No. 88-2

Piston Knock in MCM 224 CID (3.7 Litre) Engines with Aluminum Exhaust Manifolds

Borg Warner V-Drive Oil Capacity Increase

Figure 1.

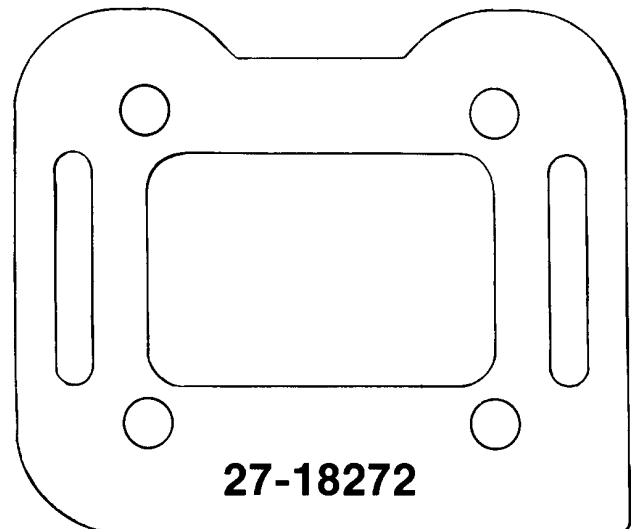
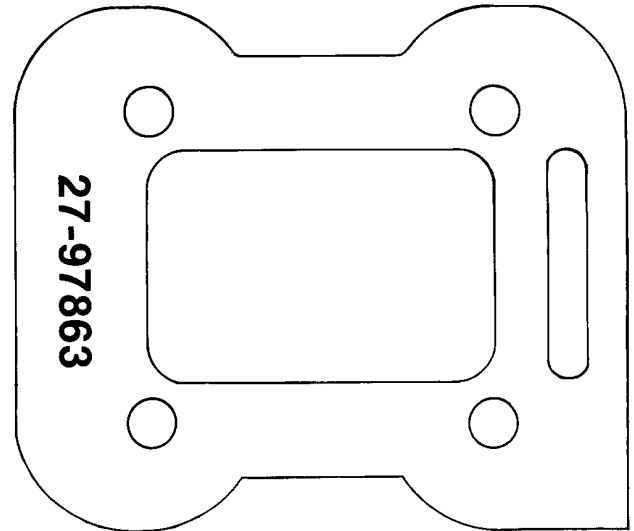
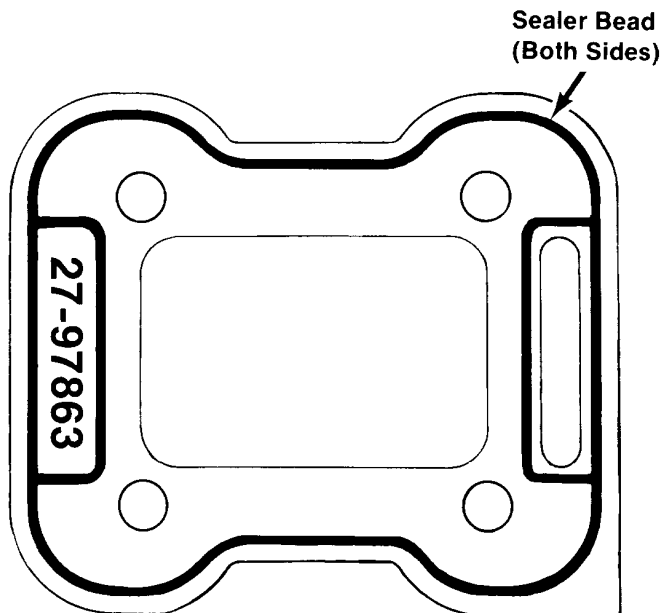
There has been a few reports on the MerCruiser 224 CID 3.7 litre engines with aluminum exhaust manifolds having a piston knock caused by a tight piston pin. The starting serial numbers of engines with aluminum exhaust manifolds are 165/170 3.7L A528109 and up, 180/190 3.7 L/LX A528516 and up. The tight pin may be caused by engine coolant entering the cylinders because of a leaking exhaust elbow/reservoir to exhaust manifold gasket part number 27-97863. The early style 27-97863 gasket had a silicon seal on both sides. The later style 27-97863 gasket was changed to a graphite type (Figure 1). 27-97863 is now superseded to 27-18272 which is a graphoil/tin composite (Figure 1). Starting serial numbers of production engines, with the 27-18272 gaskets are 165 3.7L B742442 and up 180 3.7L/LX B743204 and up. Gasket part number 27-18272 is also in Quicksilver parts stock.

Figure 2.

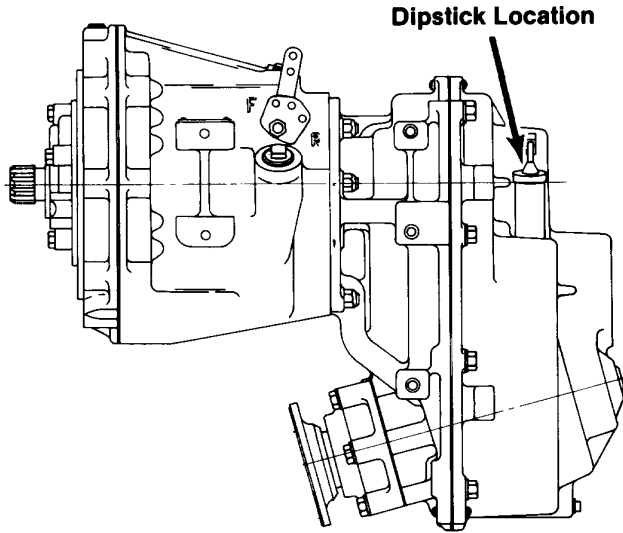
Borg Warner V-Drive transmissions with dipstick located in V-Drive case (Figure 2) that have had intermediate shaft rear bearing failure should have oil capacity increased.

Figure 3.

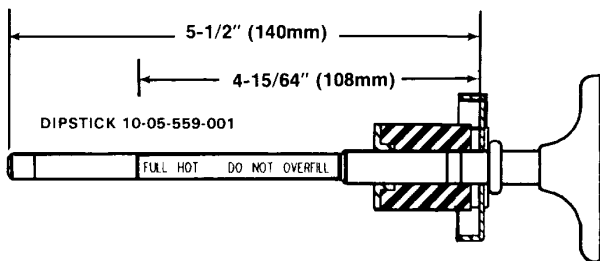
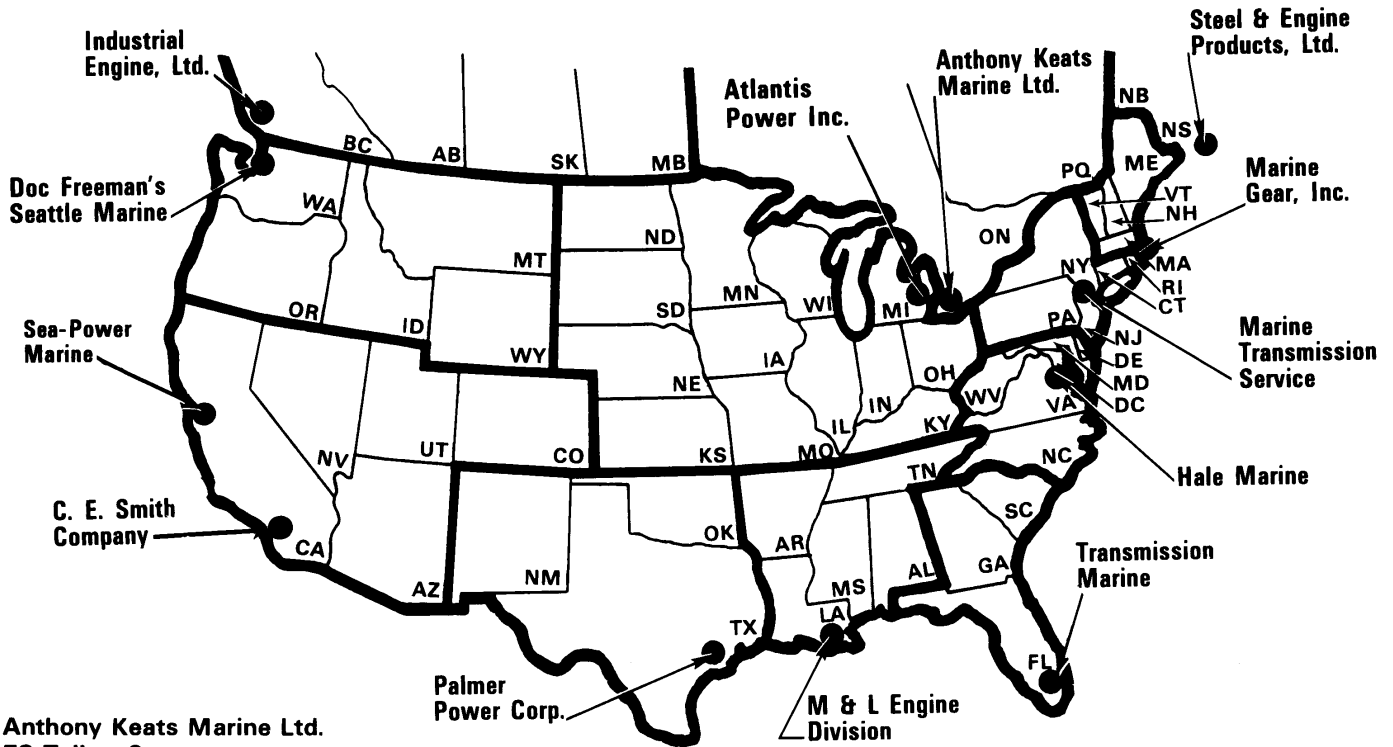
Dipstick 10-05-559-001 (Figure 3) is now available for use in Velvet Drive® V-Drive transmissions which have the dipstick in the V-Drive case. The new dipstick will provide for additional oil capacity. Order new dipstick from your closest velvet drive distributor as shown on map. The following illustration shows the dimensions of the new dipstick. It is recommended that the new dipstick be installed when servicing any V-Drive transmission which has the dipstick located in the V-Drive case.

Original dipsticks can be modified to current design by adding a mark 1" (2.5mm) above the original "full" mark. The original "full" mark then becomes the "low" or "add oil" mark.
